FRA-US62-4.90

JACKSON TOWNSHIP  
FRANKLIN COUNTY

PROJECT DESCRIPTION

TWO DRAINAGE SYSTEMS ALONG US-62 ARE PROPOSED FOR IMPROVEMENT. SYSTEM A PROPOSED WORK ENTAILS CONSTRUCTING A MANHOLE TO CONNECT TWO 36" PIPES. THE OUTLETTING 36" PIPE AND THE 42" PIPE IT IS CONNECTED TO ARE TO BE REPLACED WITHOUT DISTURBING THEIR CONNECTING JUNCTION CHAMBER. FOR SYSTEM C, REPLACE A JUNCTION CHAMBER WITH A CATCH BASIN AND PLACE A NEW 24" PIPE RUN.

SCHEMATIC PLAN

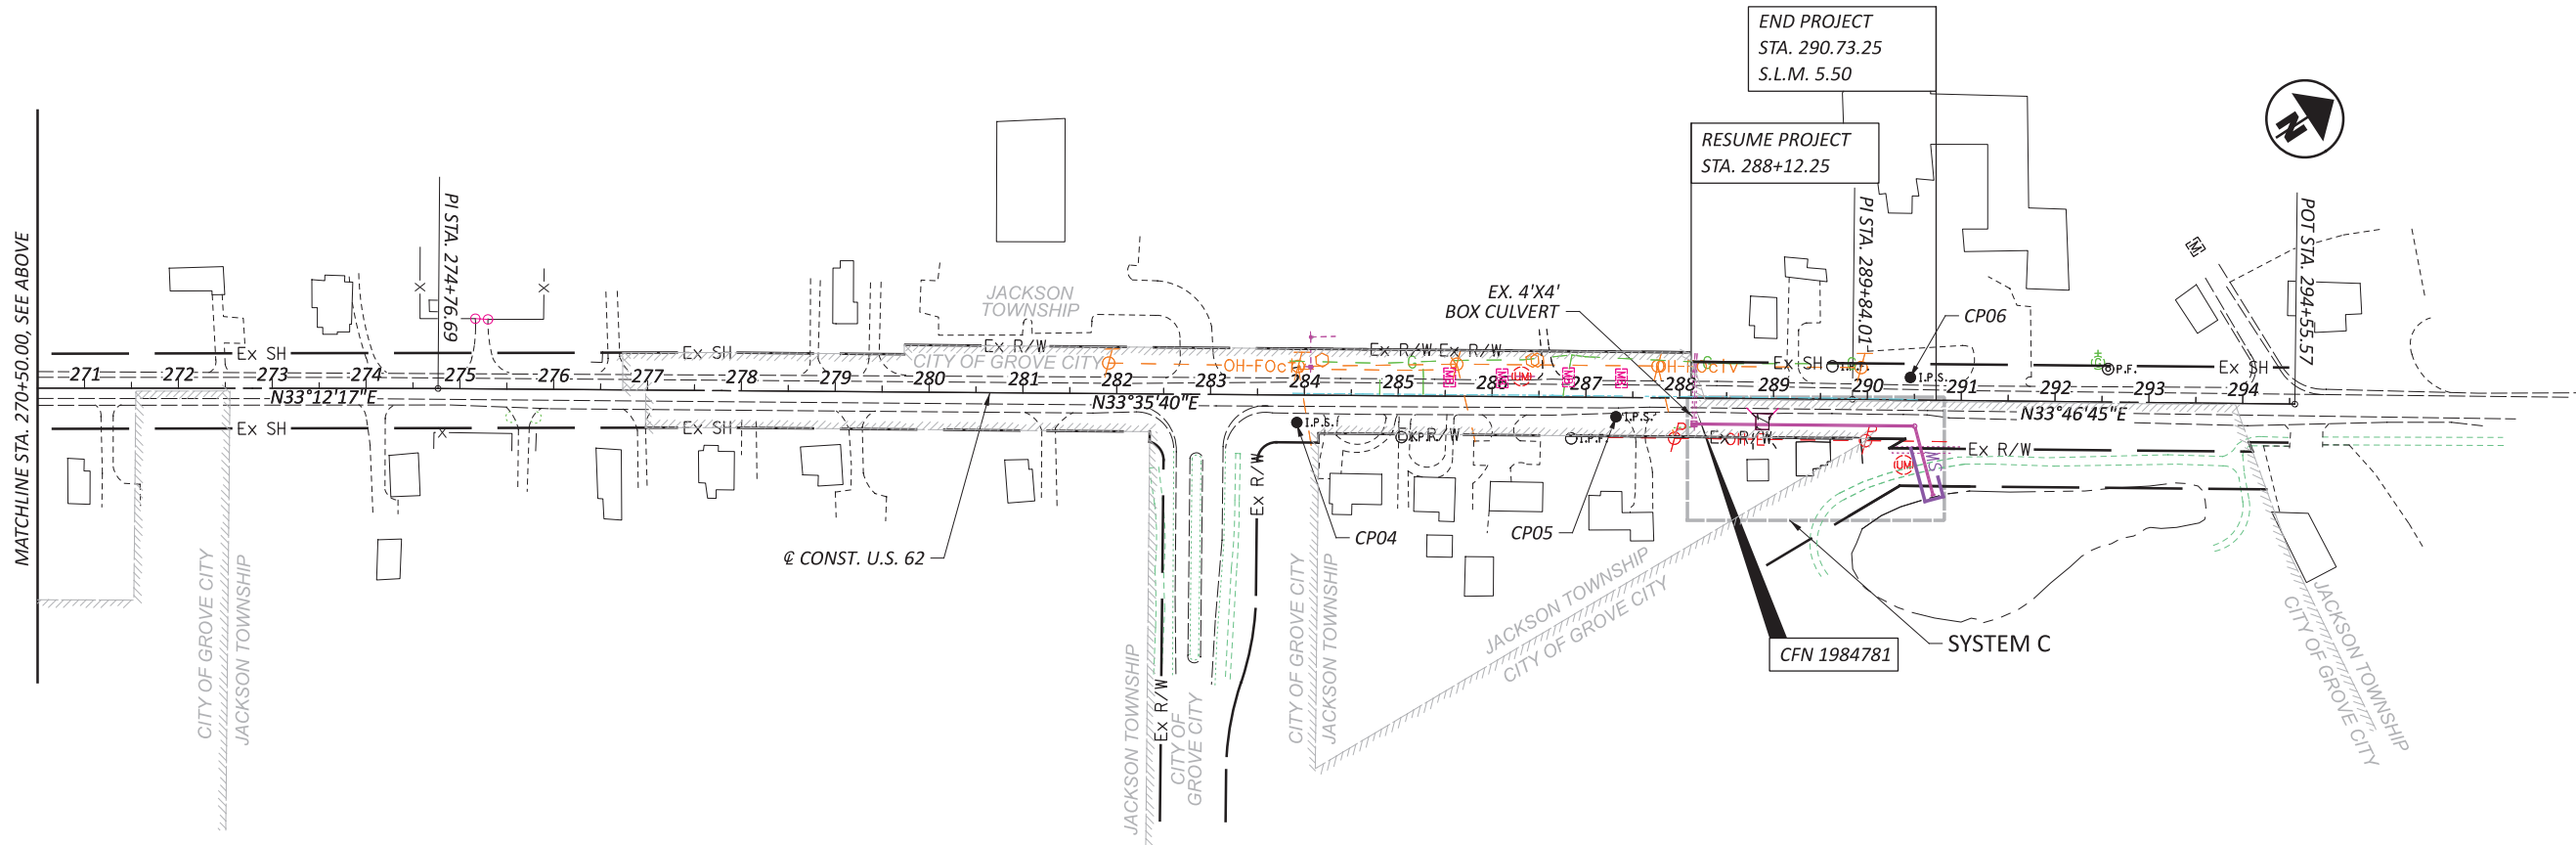
Add names for side roads.  
Addresses and/or property id

CROSS SECTIONS - SYSTEM A  
STA. 259+00.00 TO STA. 260+25.00

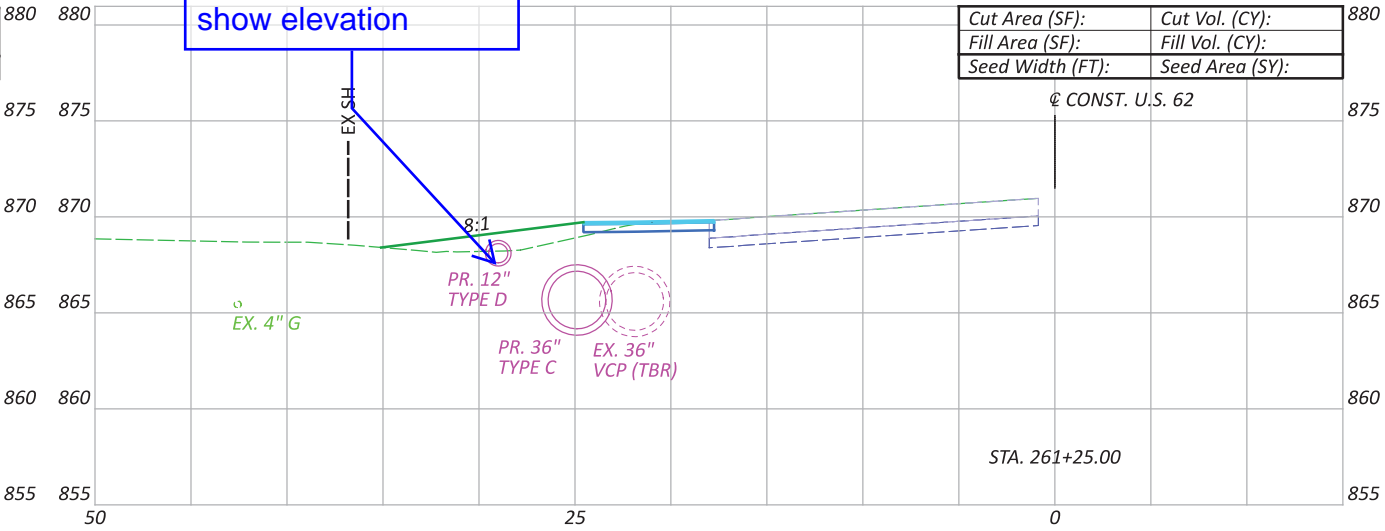
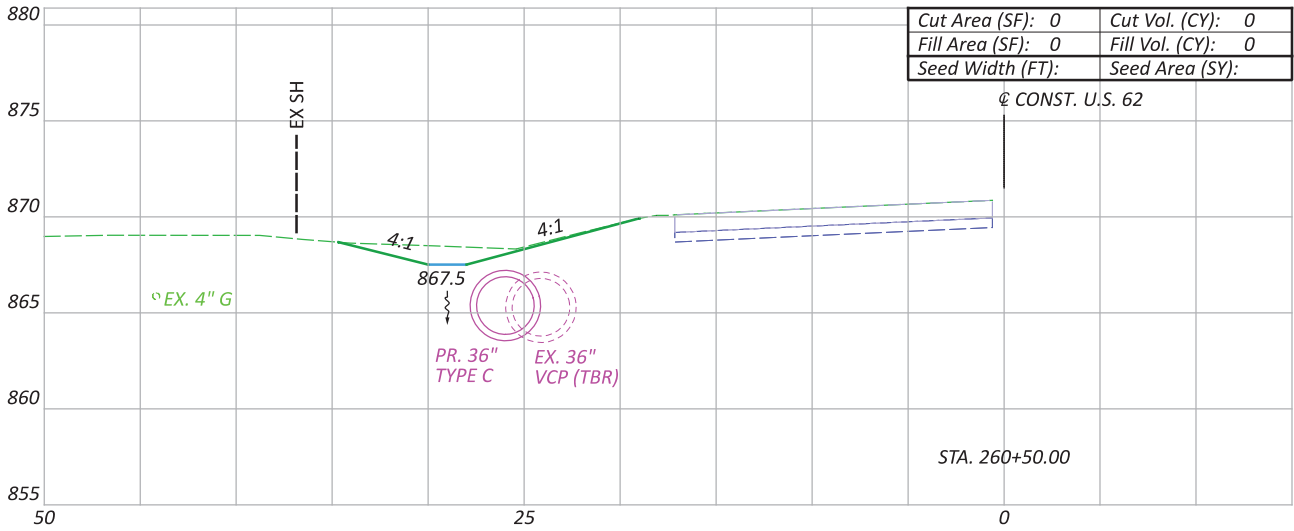
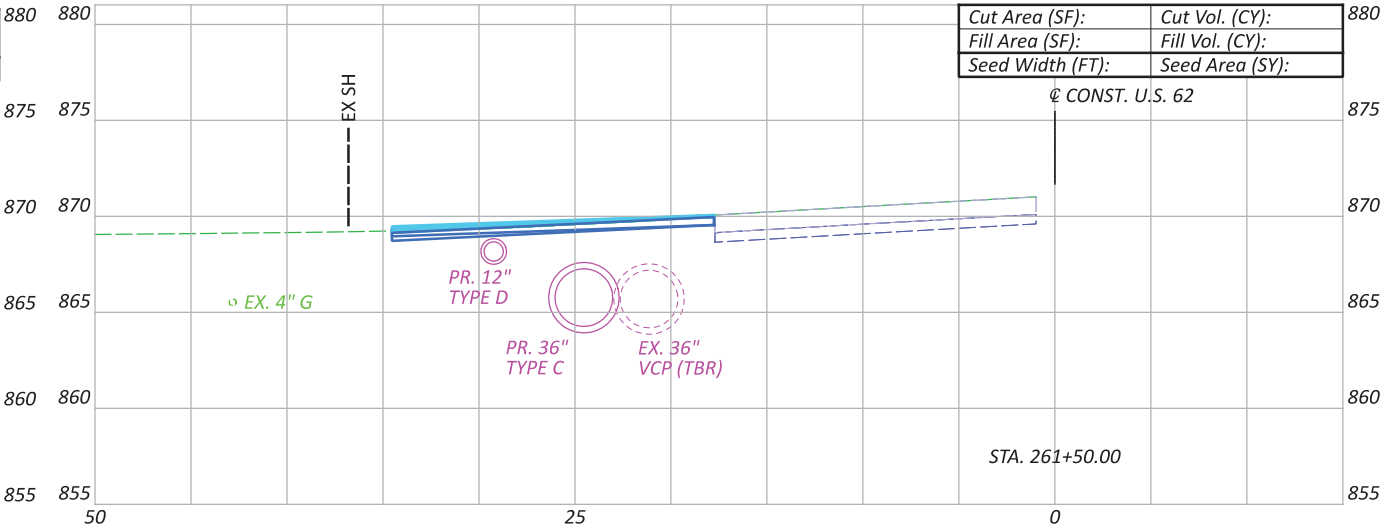
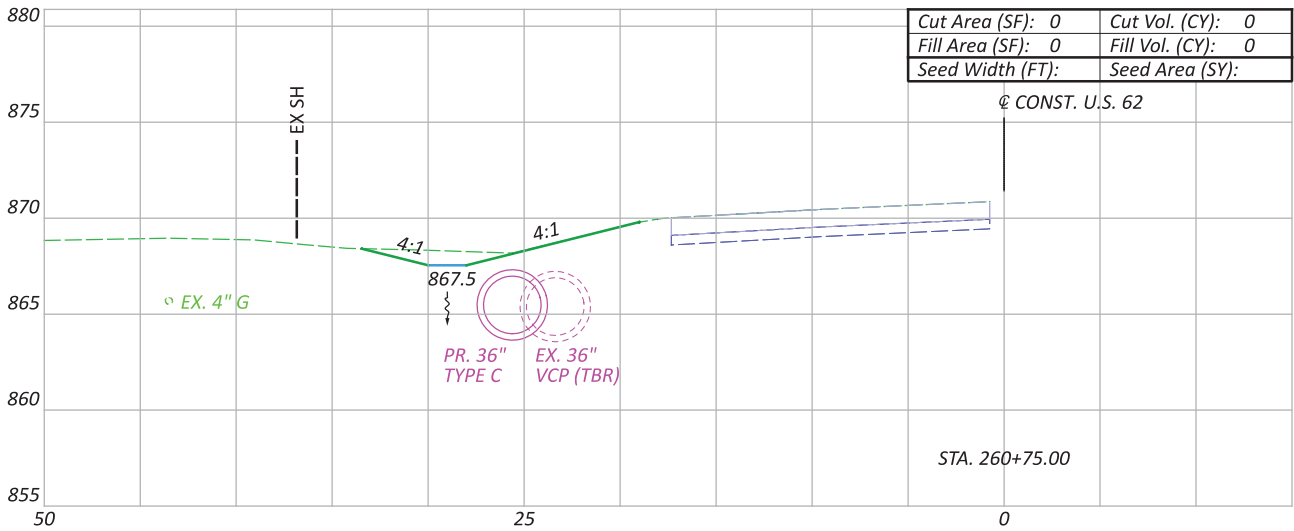
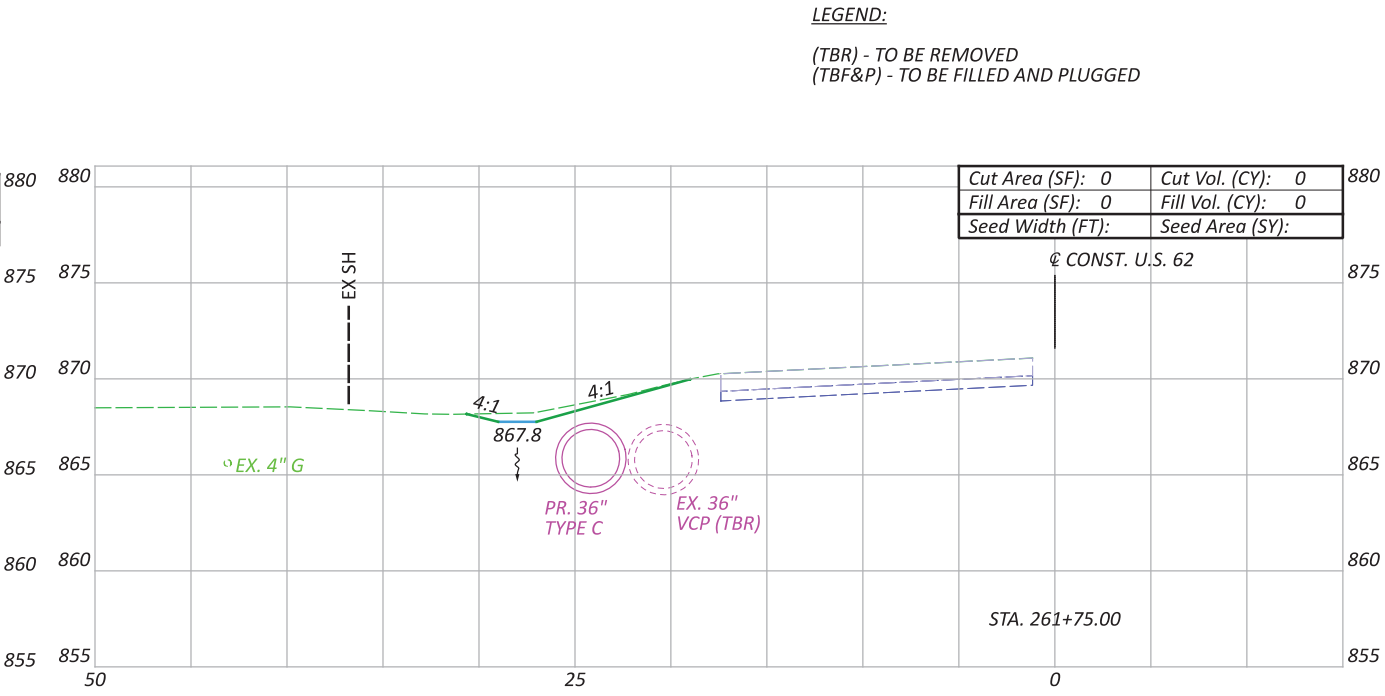
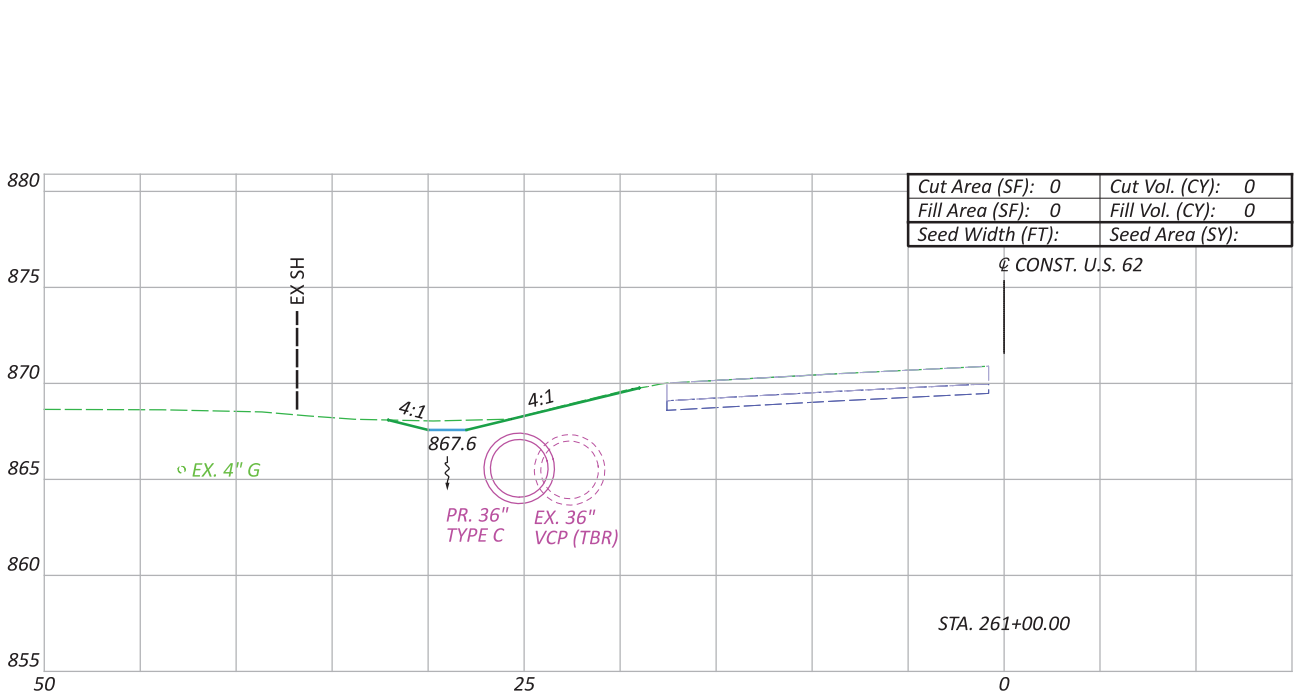
show RW on all cross sections.
